**TO:** Chairwoman Carlotta Harrell, Henry County Commission  
**ATTN TO:** Kenta Lanham, Planner III, Henry County  
**FROM:** Mike Alexander, COO, Atlanta Regional Commission  
**RE:** Development of Regional Impact (DRI) Review

**Name of Proposal:** Pates Creek Subdivision DRI 4176

**PATES CREEK SUBDIVISION DRI**  
**Henry County**  
**Natural Resources Review Comments**

# DRI SITE PLAN FOR GATES AT PATES CREEK PHASE I, II, & III

OVERALL SITE PLAN  
FOR  
GATES AT PATES CREEK  
PHASE I, II, & III  
LOCATED IN:  
LAND LOT 73, 74, 87, 88, 6TH DISTRICT  
HENRY COUNTY, GEORGIA

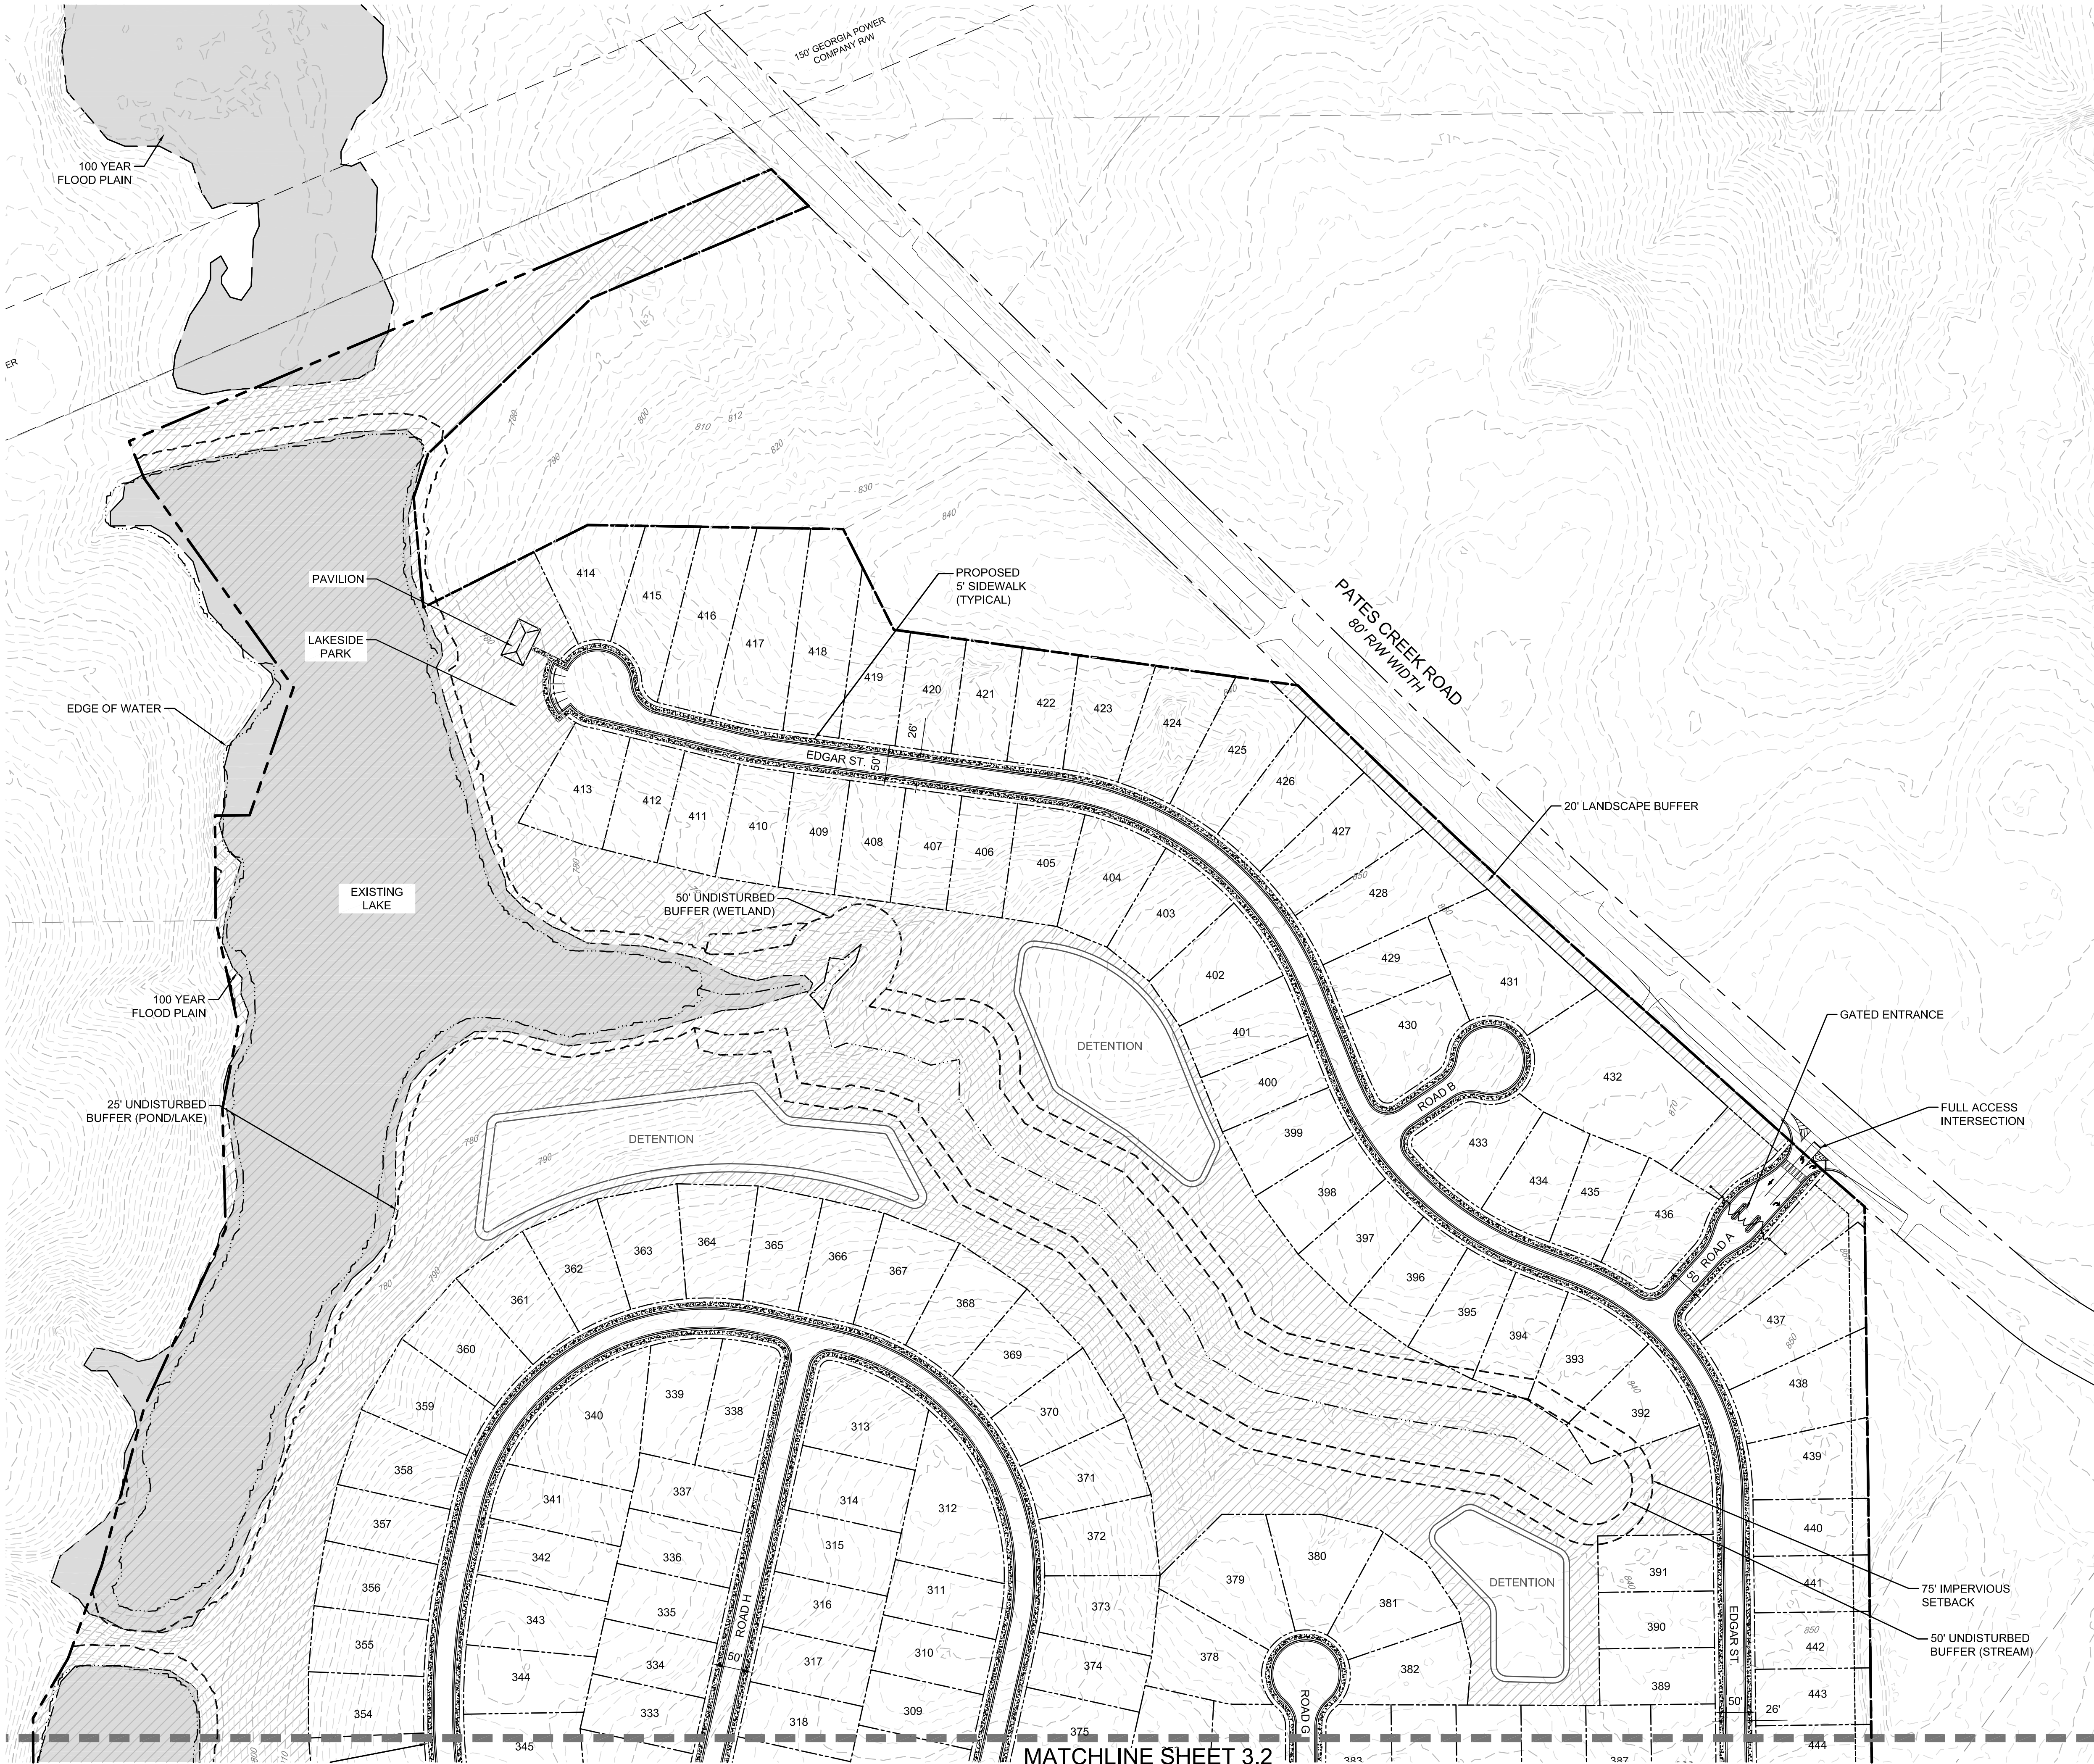
*The site plan shows streams and buffer zones intruding on numerous lots, with several lots having little or no room for development outside the setbacks and standard setbacks from the proposed streets. The developer will need to show that the remaining undeveloped lots in Phase II and Phase III can and will be developed outside the limits of the buffers, or variances will be required from Henry County. The criteria for such variances should be clearly communicated.*

*The overall site includes substantial flood plain areas. Most of the Phase 3 lots appear to be outside of the flood plain areas. However, multiple parcels in Phases 1 and 2 extend into the 100 year flood plain which is a FEMA designated Special Flood Hazard Area. Any properties either completed or scheduled for construction that extend into the flood zone should be reviewed for consistency with proper flood zone compliance. As flooding in the region becomes an increasing concern, every effort should be made to reduce flooding risks to lives and property.*

The FEMA floodplain coverage for the project area shows Zone A 100-year floodplain along the primary unnamed tributary (Pates Creek Tributary 6 on the FEMA coverage), which is also shown as 100-year floodplain on the project site plan. As with the buffer zones, the portion of the mapped floodplain south of the southernmost lake on the plans crosses several of the lots on Goodwin Drive in Phase II, which are currently being developed. There appear to be no floodplain intrusions into the proposed lots in Phase III.

Ideally, single-family lots sold for development are situated outside of adjacent stream buffers. This ensures that encroachments are not later added by homeowners. When lots extend into buffers, the local government bears the responsibility of ensuring that the actual construction remains outside of stream buffers or that required buffer variances are obtained. A number of the proposed lots appear to extend so far into the buffers that it is unknown if a house can be constructed outside of the buffers.

DATE	ADDED FLUID PLAIN PER ARC COMMENTS
1. 01/24/25	
2.	
3.	
4.	
5.	
6.	
7.	
8.

SITE PLAN  
FOR  
GATES AT PATES CREEK  
PHASE I, II, & III  
LOCATED IN:  
LAND LOT 73, 74, 87, 88, 6TH DISTRICT  
HENRY COUNTY, GEORGIA

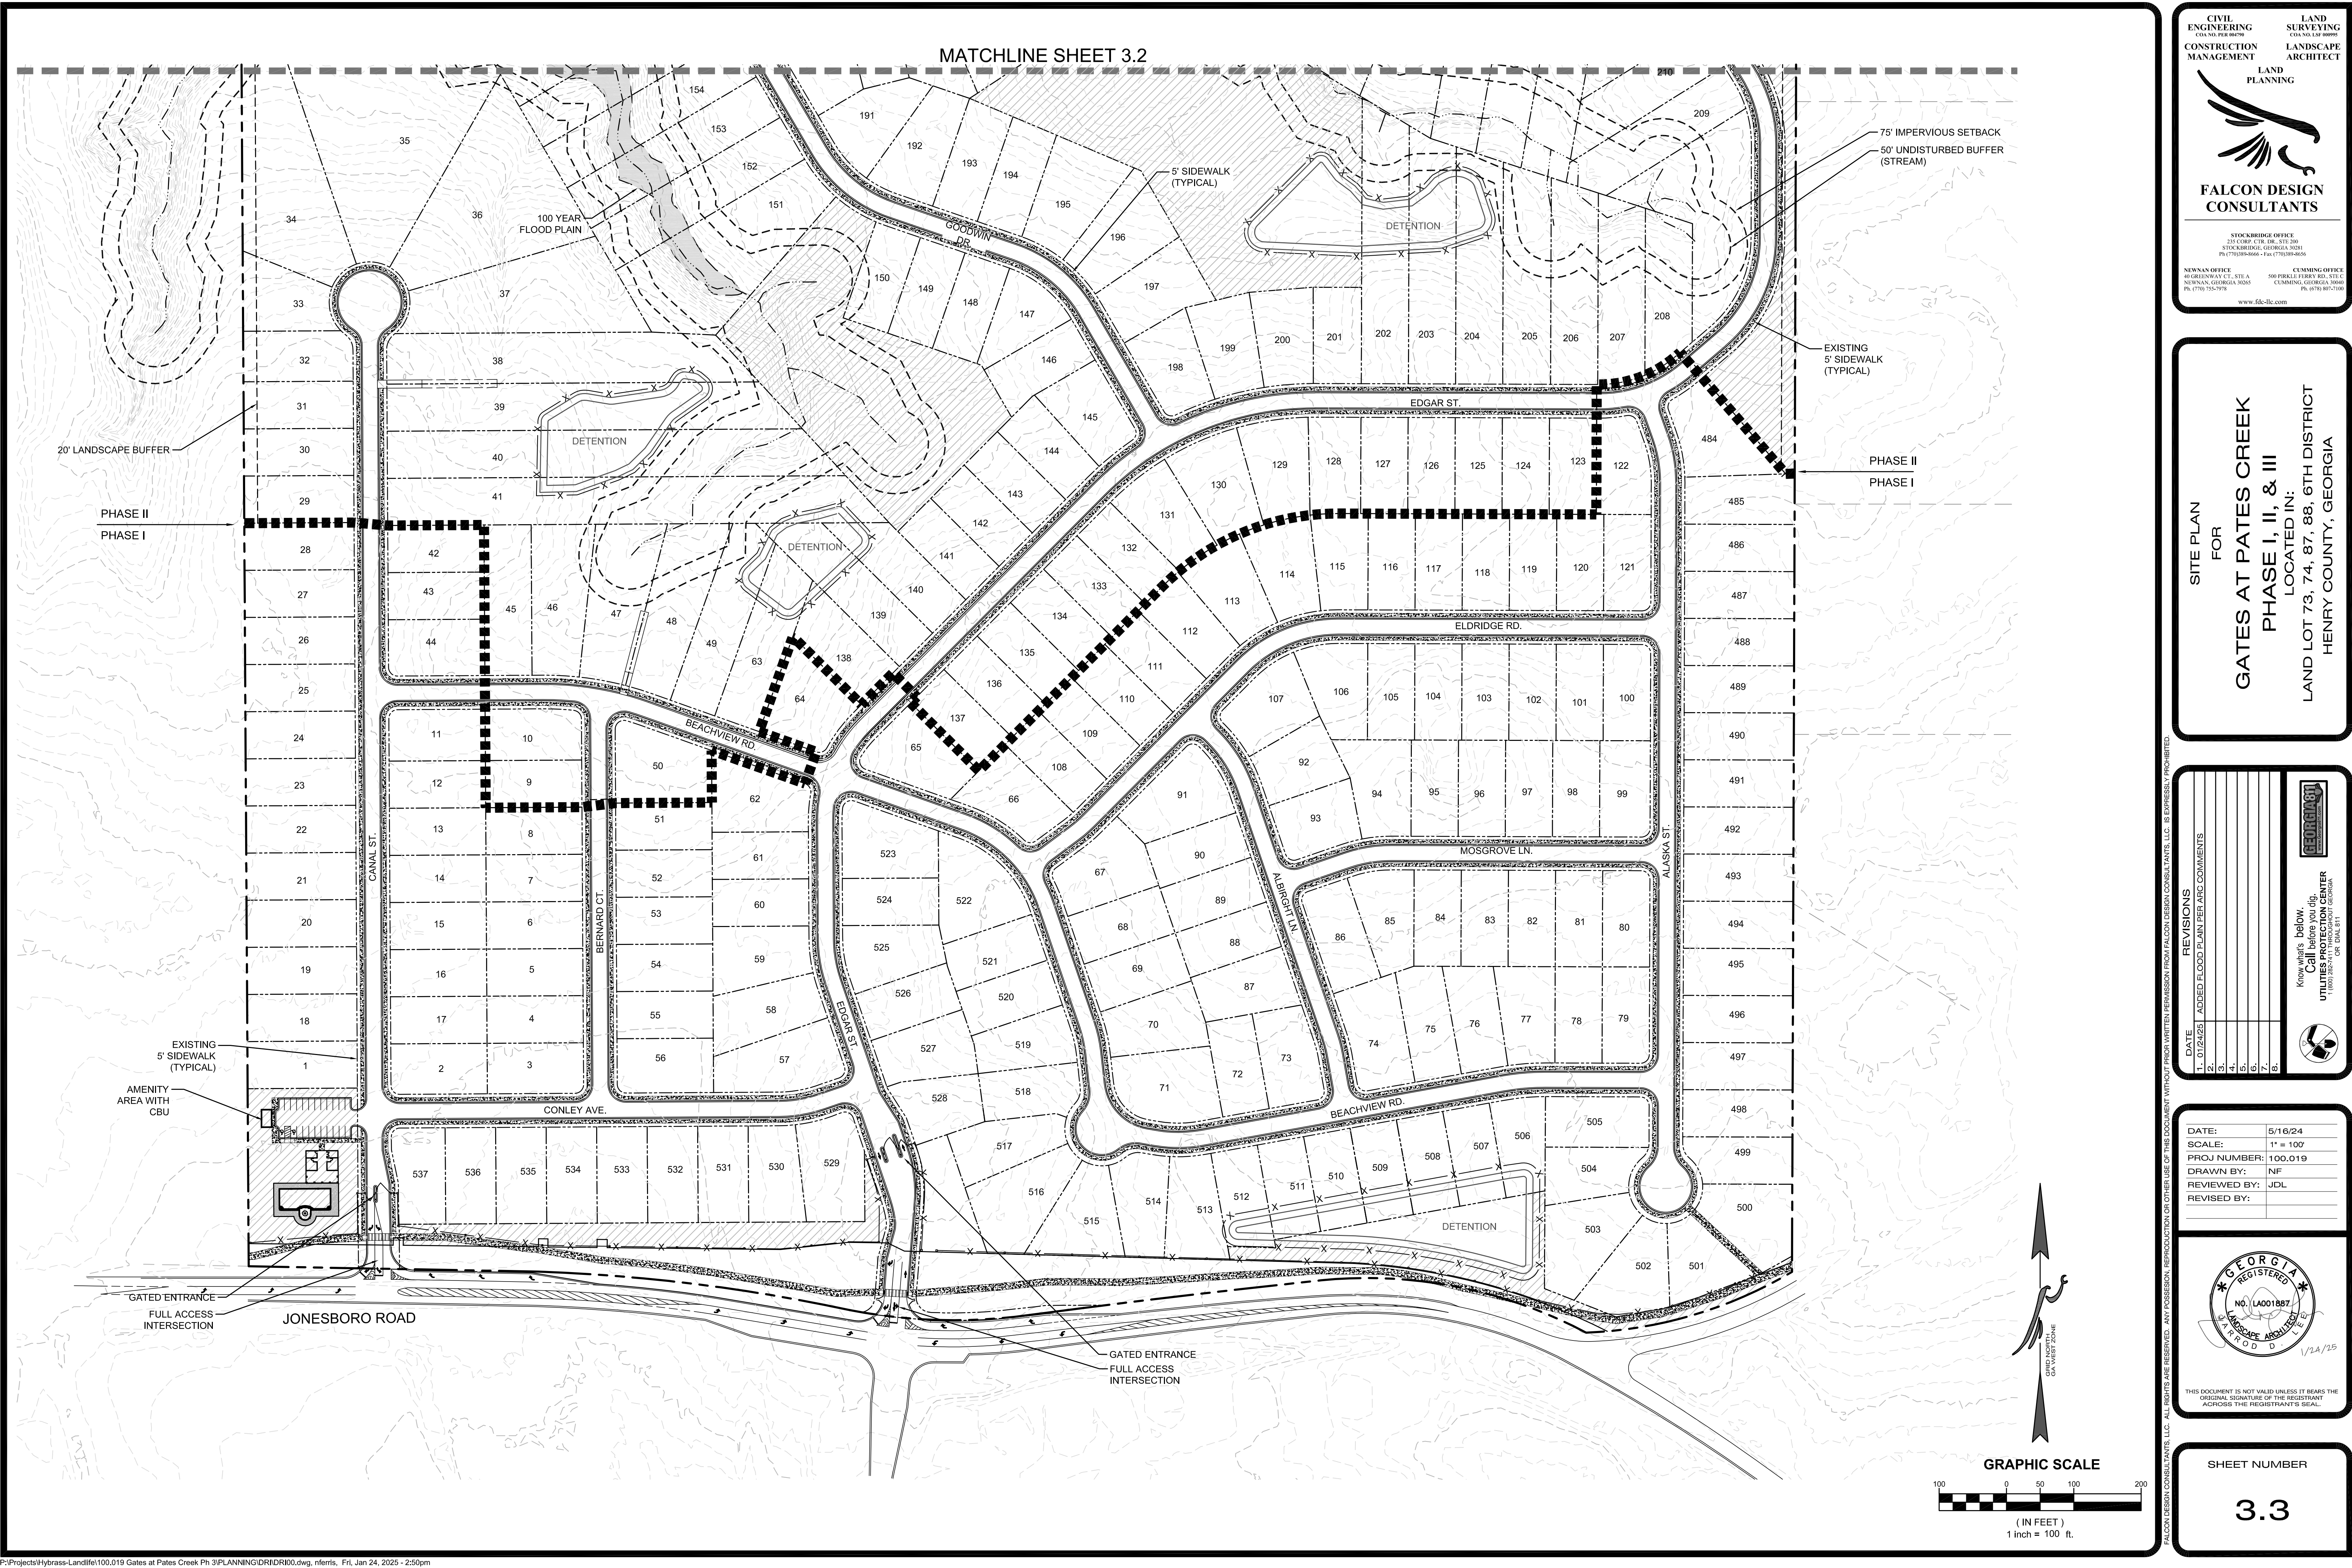
The site plan and the USGS coverage for the project area both show an unnamed intermittent tributary to Pates Creek (which is identified on FEMA coverage as Pates Creek Tributary 6), which in turn is a tributary to Little Cotton Indian Creek. The tributary runs roughly south to north across the project property, with several unmapped stream branches shown on the site plan. The site plan shows and identifies the County 50-foot undisturbed buffer and 75-foot impervious surface setback on all streams. However, the 25-foot State Erosion and Sedimentation Act buffer, while shown around the existing lakes, is not shown along the streams on the site plan. In addition, the submitted site plan shows streams and buffer zones intruding on numerous lots, with several lots having little or no room for development outside the setbacks and standard setbacks from the proposed streets. A number of these lots are in Phase I and Phase II and are already developed or are under development. The developer will need to show that the remaining undeveloped lots in Phase II and Phase III lots can and will be developed outside the limits of the buffers, or

variances will be required from Henry County. Any other unmapped streams on the property are subject to the county stream buffer ordinance and all waters of the state on the property are subject to the 25-foot State Erosion and Sedimentation Act buffer.

DATE	ADDED FLOOD PLAN PER AEC COMMENTS
1. 07/24/25	
2.	
3.	
4.	
5.	
6.	
7.	
8.
